2.2 Control and Instrument Systems

The information in this section of the reference ABWR DCD, including all subsections, tables, and figures, is incorporated by reference with the following departures.

Figure 2.2.1 Rod Control and Information System Control Interface Diagram

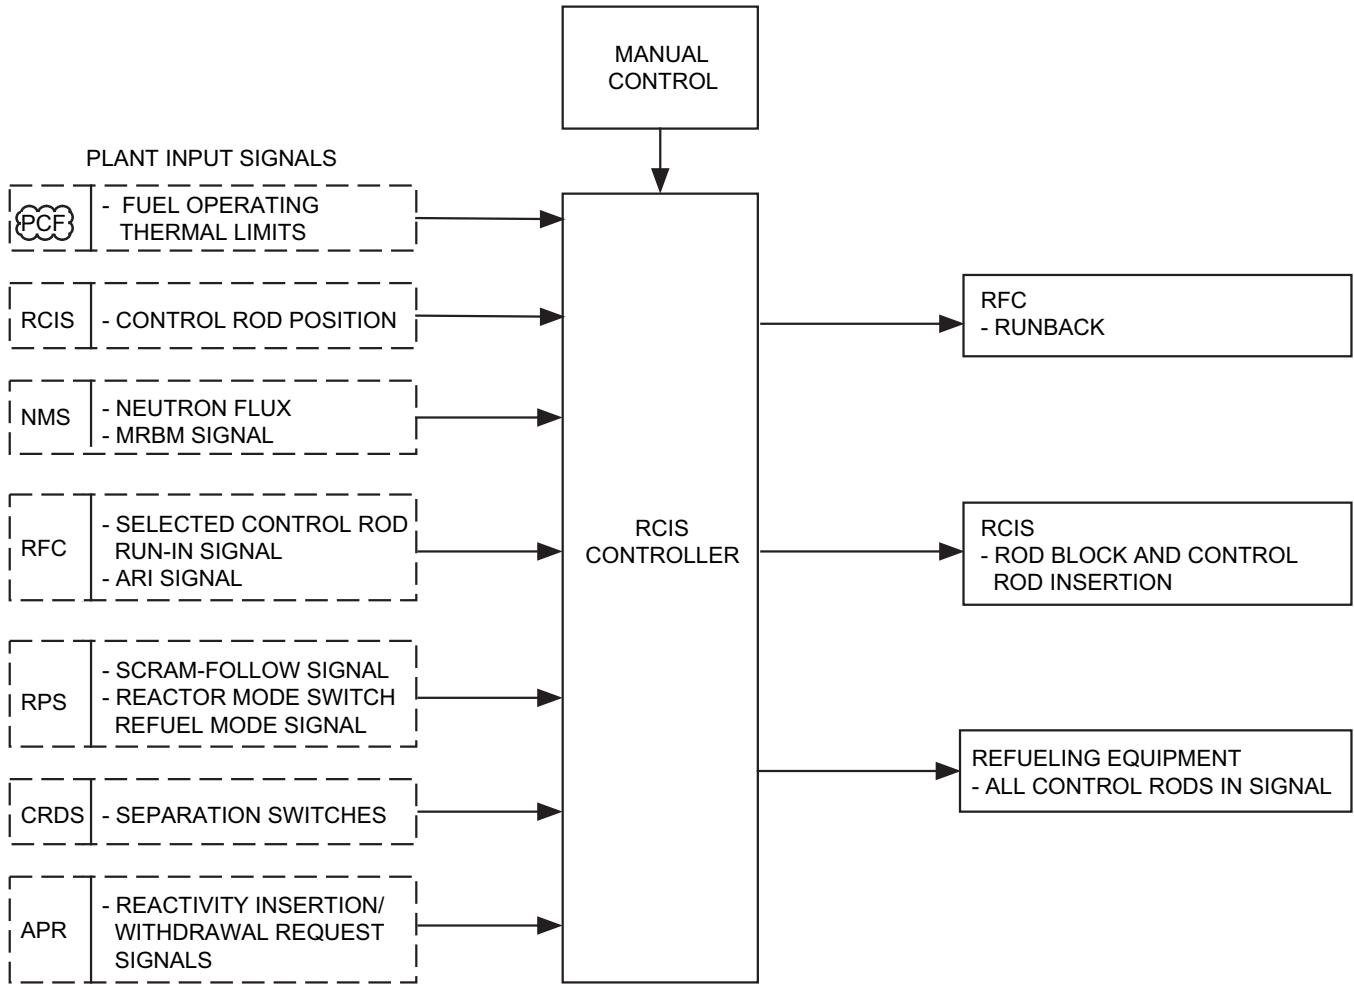
STD DEP T1 3.4-1 (Figure 2.2.1)

NOTE:
1. INTERCONNECTIONS MAY BE FIBER-OPTIC OR METALLIC.

Figure 2.2.5 Neutron Monitoring System

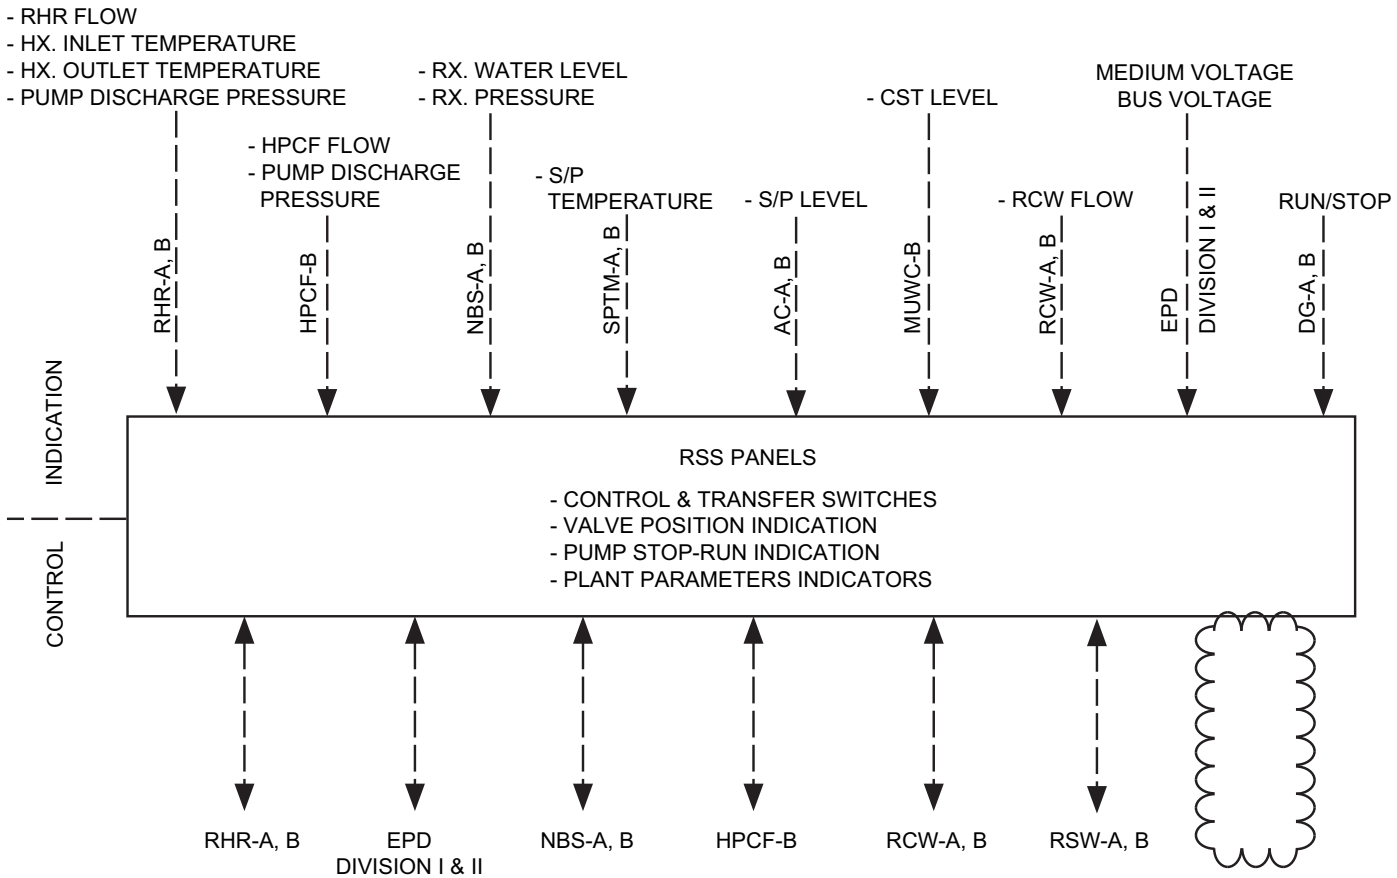
STD DEP T1 3.4-1 (Figure 2.2.5)

1. DIAGRAM REPRESENTS ONE OF FOUR NMS DIVISIONS (MRBM IS A DUAL CHANNEL SYSTEM. THERE IS ONLY ONE IN-CORE INSTRUMENT CALIBRATION SYSTEM).
2. USED FOR RAPID CORE FLOW DECREASE TRIP.
3. SRNM AND APRM ATWS PERMISSIVE SIGNALS TO SSLC.
4. INTERCONNECTIONS MAY BE FIBER-OPTIC OR METALLIC.

Figure 2.2.7b Reactor Protection System

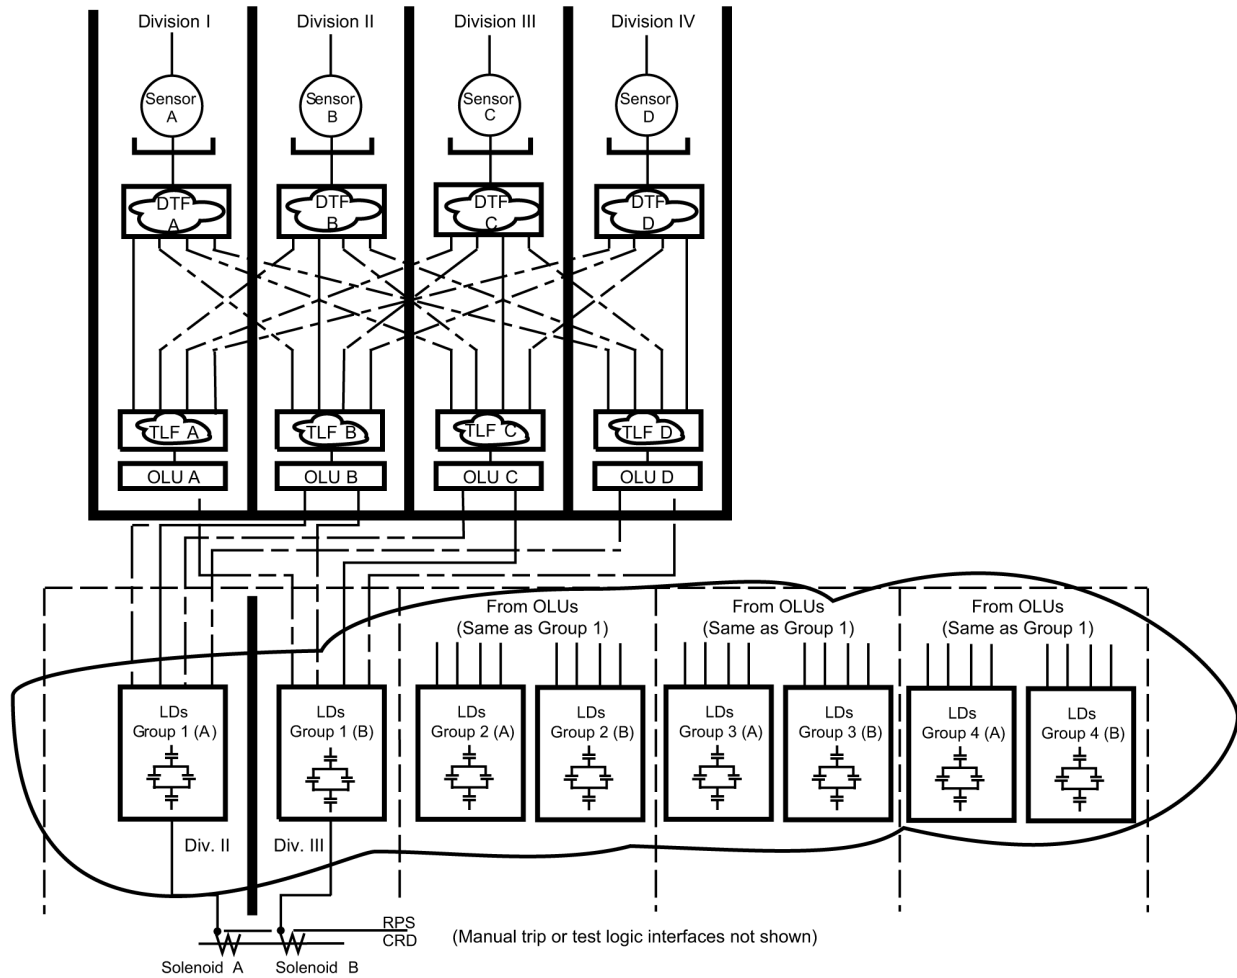
STD DEP T1 3.4-1 (Figure 2.2.7b)

The RPS has four divisions. Figure ~~2.2.6a~~ 2.2.7b shows the RPS divisional aspects and the signal flow paths from sensors to scram pilot valve solenoids. Functions Equipment within an RPS division consists of include sensors (transducers or switches), I/O, multiplexers, data communication, digital trip modules functions (DTM DTF), trip logic unit function (TLU TLF), output logic unit (OLU), and load drivers (LD). The LDs are only in Divisions II and III. The (DTF) and (TLF) are performed in digital configurable logic devices. The data communication functions are described in Section 2.7.5.
